From: Sent: To: Subject: Attachments: Morel, Brian P Thursday, April 15, 2010 4:00 PM Jesse Gagliano; Hafle, Mark E; Cocales, Brett W; Walz, Gregory S RE: OptiCem Report image002.jpg; image003.jpg

To: Hafle, Mark E; Morel, Brian P; Cocales, Brett W; Walz, Gregory S Subject: OptiCem Report

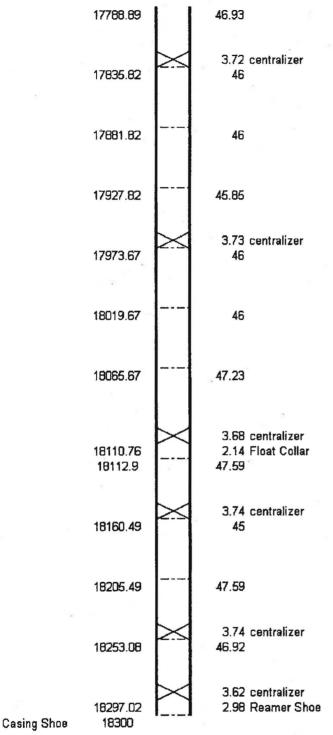
We have 6 centralizers, we can run them in a row, spread out, or any combinations of the two. It's a vertical hole so hopefully the pipe stays centralized due to gravity. As far as changes, it's too late to get any more product to the rig, our only options is to rearrange placement of these centralizers. Please see attached diagram for my recommendation.
